CITY OF TAYLOR, TEXAS

PLANNING AND ZONING COMMISSION MEETING

June 14, 2022, 6:00 P.M.

2. **PZ-2021-1281** – Consider disapproving RCR-Taylor Logistics Park Phases 1, 2, and 3 Preliminary Plat, consisting of approximately 756.00 acres of land, addressed as 201 FM 3349, more particularly described by Williamson Central Appraisal District Parcels R019173, R019450, R349685, R435559, R435560, R586971, R586972, R586973, R586974, R605658, R605702, R619617, and R621879, part of and out of the Watkins Nobles Survey, Abstract No. 484 and James C. Eaves Survey, Abstract No. 213, Taylor, Williamson County, Texas.

THE RETREAT AT MALLARD PRELIMINARY PLAT

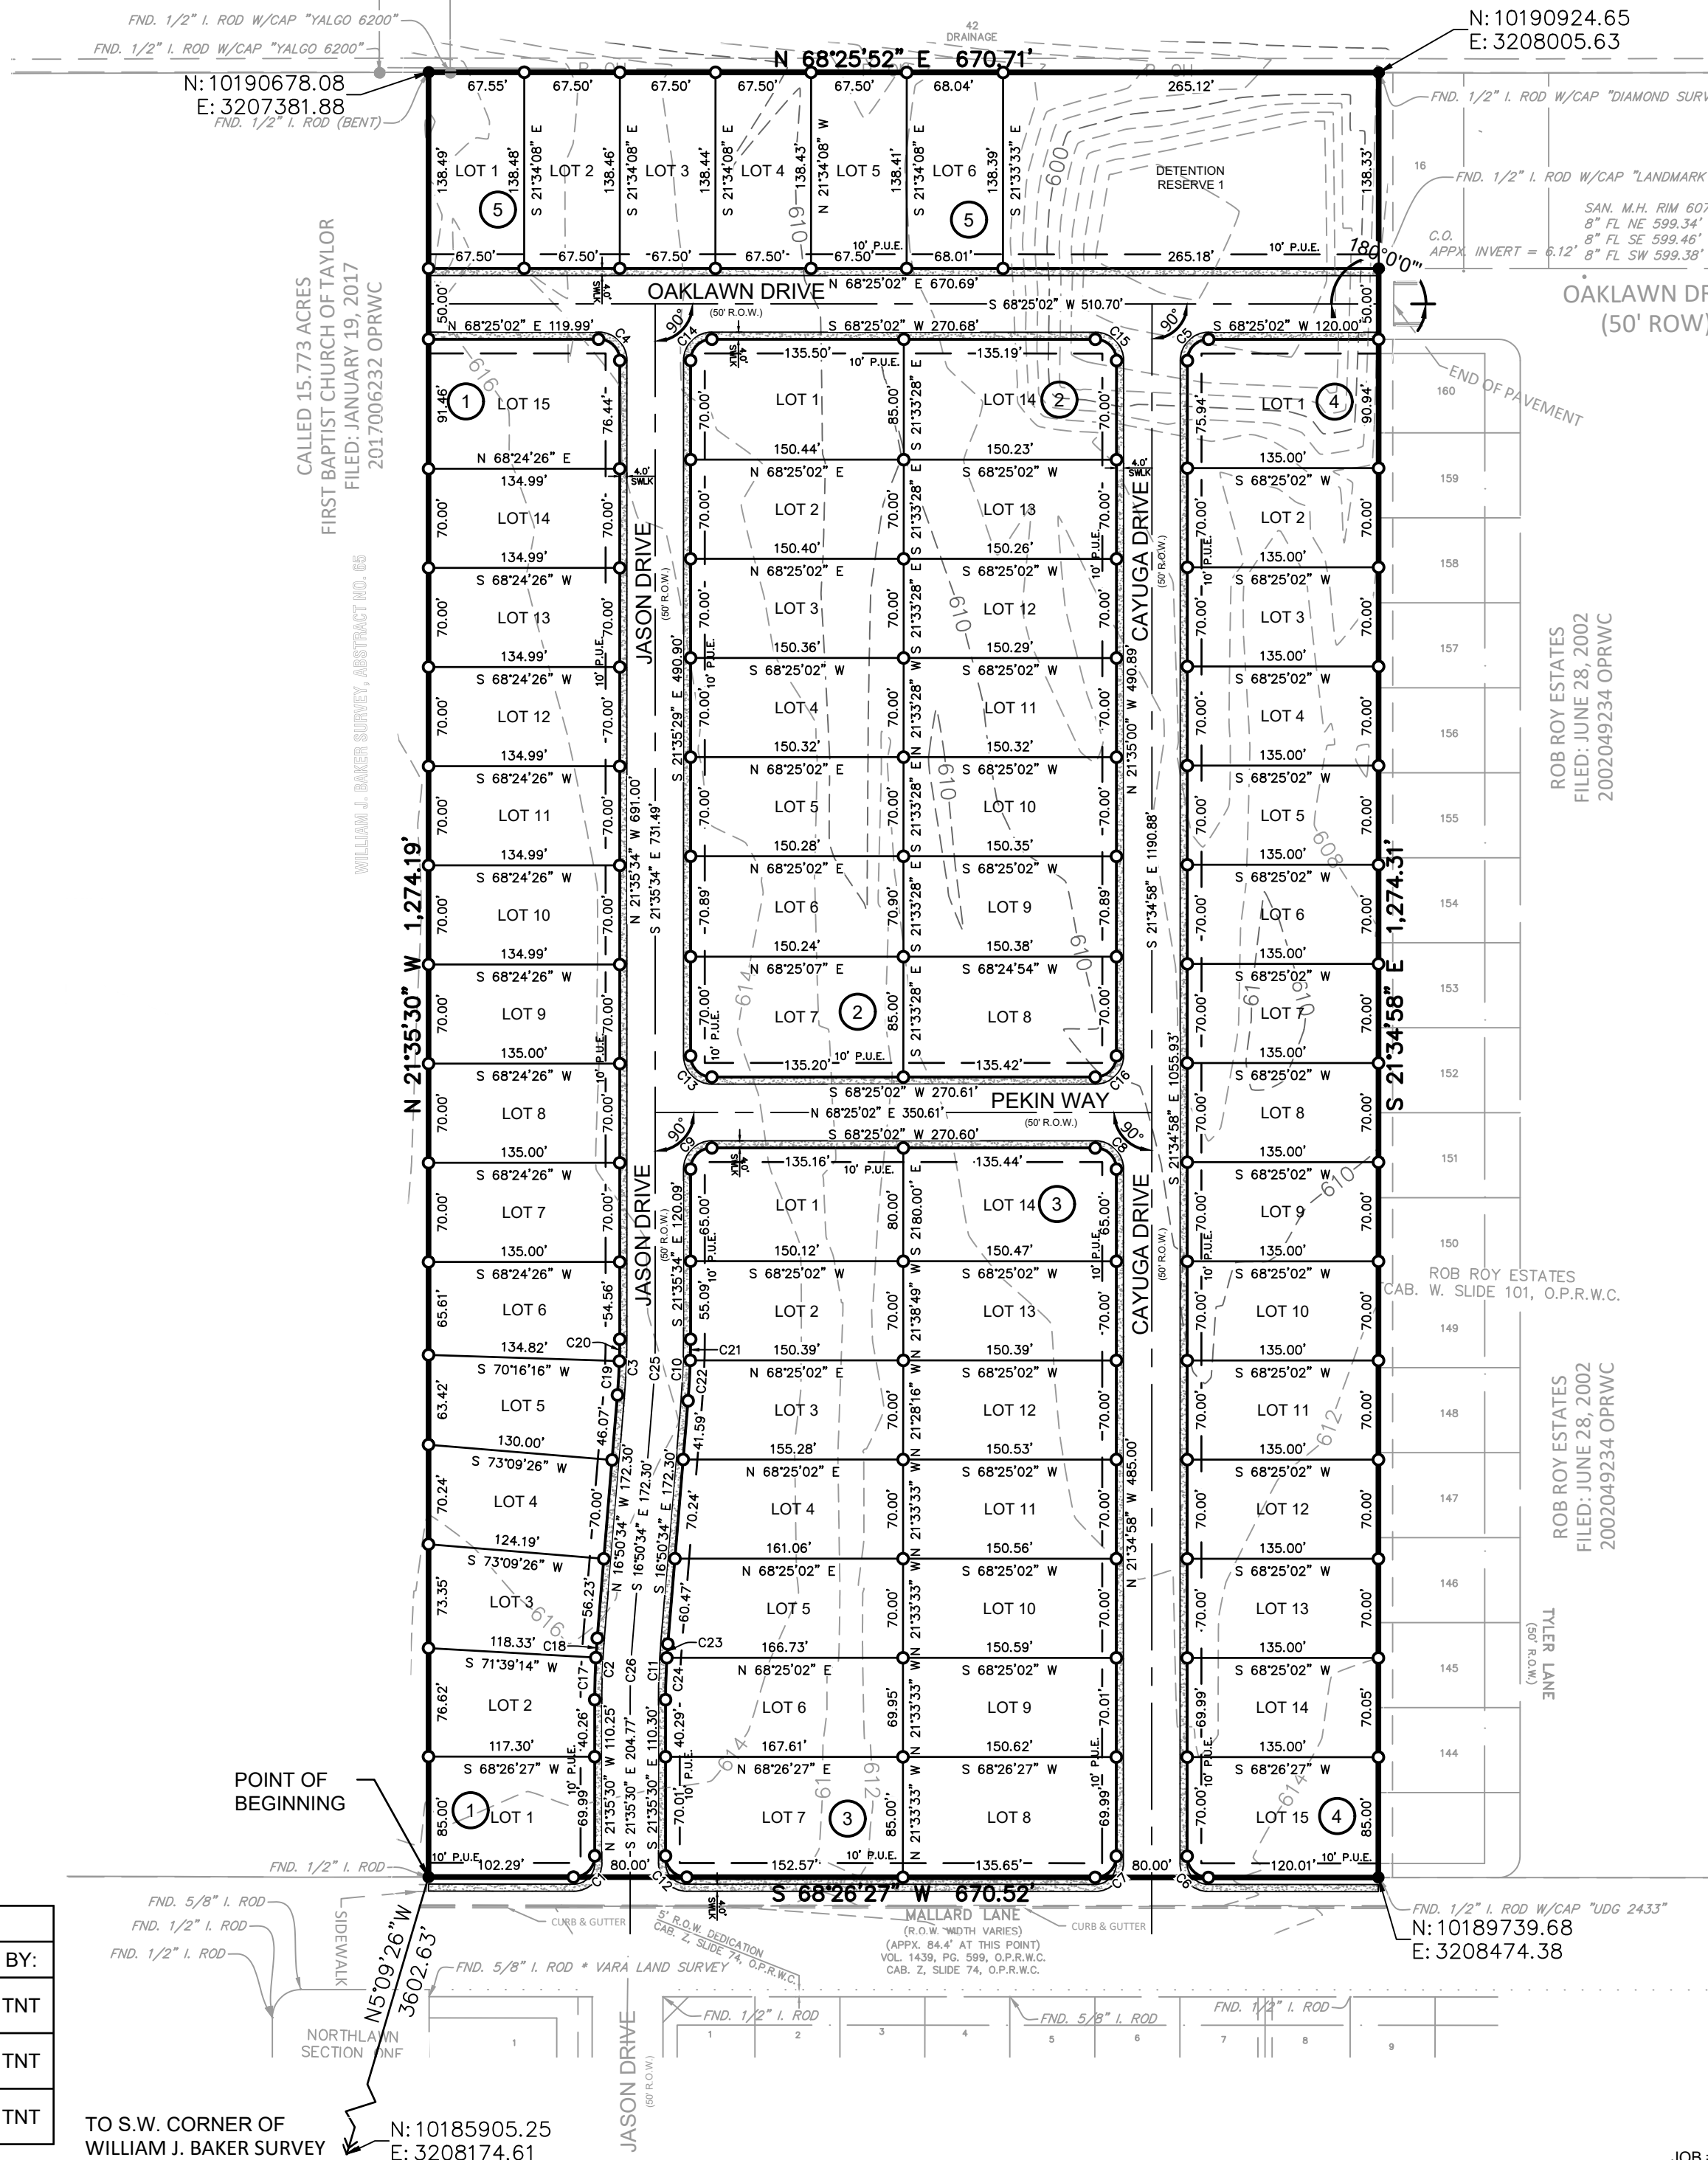
Sheet 1 of 2 -

1. Provide a reference on the plat drawing and include note to satisfy the following plat requirement: Easement for drainage adjacent to lots, tracts, or reserves shall be noted: "This easement shall be kept clear of fences, buildings, planting, and other obstructions to the operations and maintenance of the drainage facility." (Subdivision Ord. 3.3.2 Requirements for Easements, 4.)
2. Minimum Finished Floor Elevation (FFE) to be noted on the plat for lots located in the within the 100-yr floodplain (Subdivision Ord. 3.3 Final Plat, 10.b)
3. Verify: A portion of Cecilia Street ROW will be improved with this development; therefore, this should be removed.
4. Update submittal date to current submittal.
5. Show 10-ft PUE noted on Sheet 2 General Notes.

Sheet 2 of 2 -

1. Remove repeated County Clerk block.
2. The final plat shall also contain certification by a licensed professional engineer that certifies that "the information contained on the plat complies with all ordinances adopted by the City". (Subdivision Ord. 3.3 Final Plat, 10.c)
3. Provide the following plat general note: No development shall begin prior to the issuance of a Floodplain Development Permit for each of the following lots: _____ (Taylor Plat Application, Plat Content Requirements, 8.f)

MULE LOOP TOWNHOMES, BLOCK 1, LOT 1, FINAL PLAT

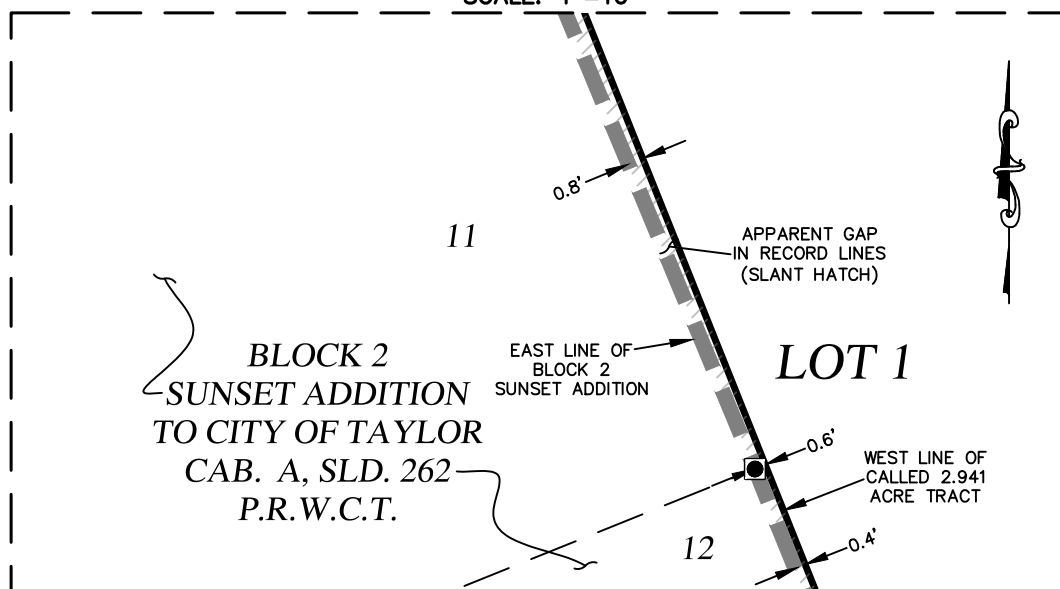
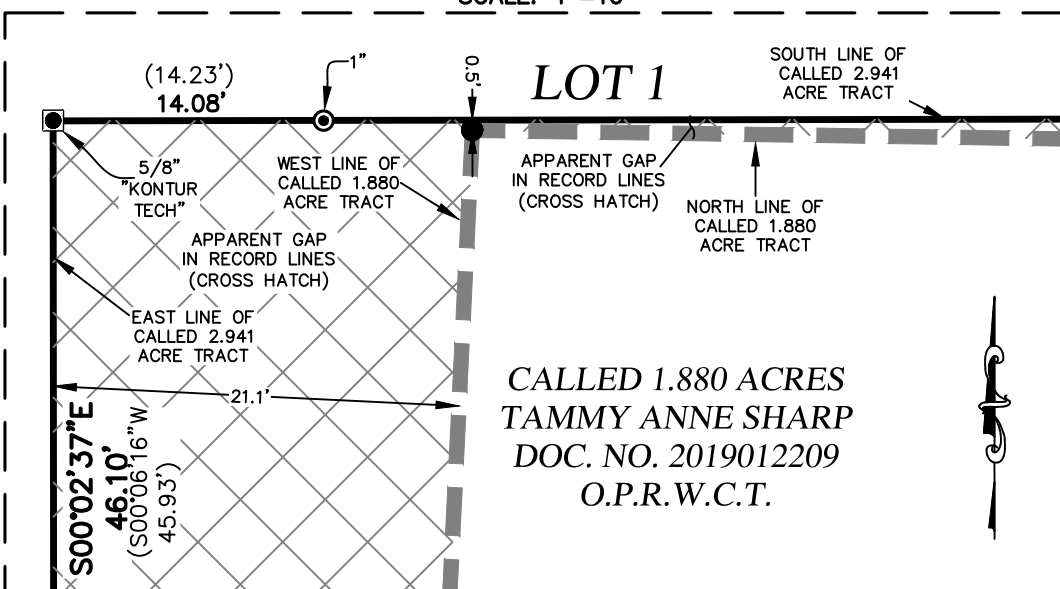
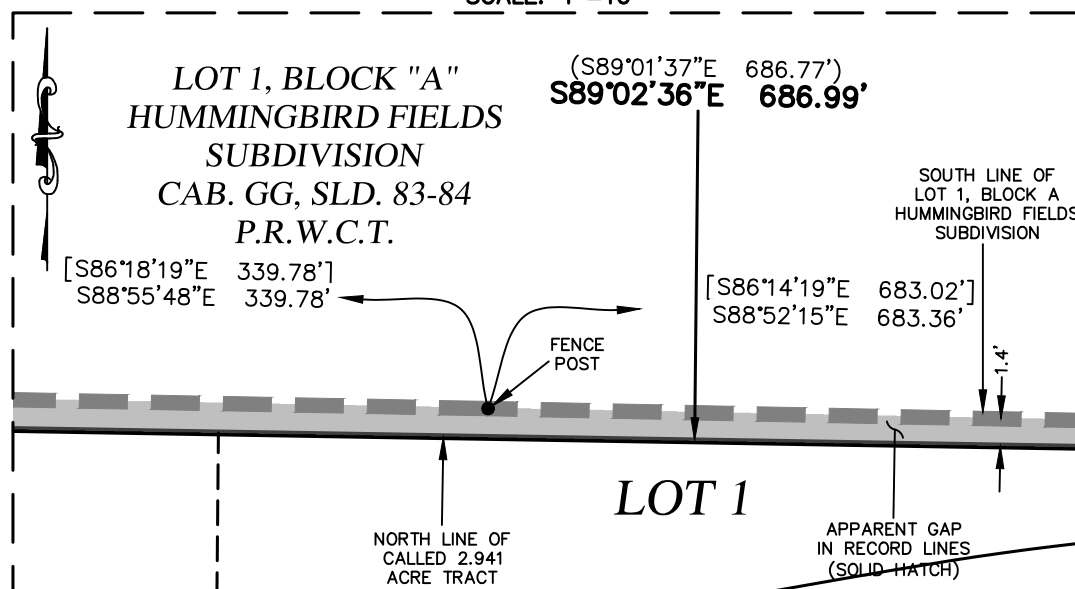
1. Please revise all applicable plans/documents to reflect the correct spelling of "Cecelia".
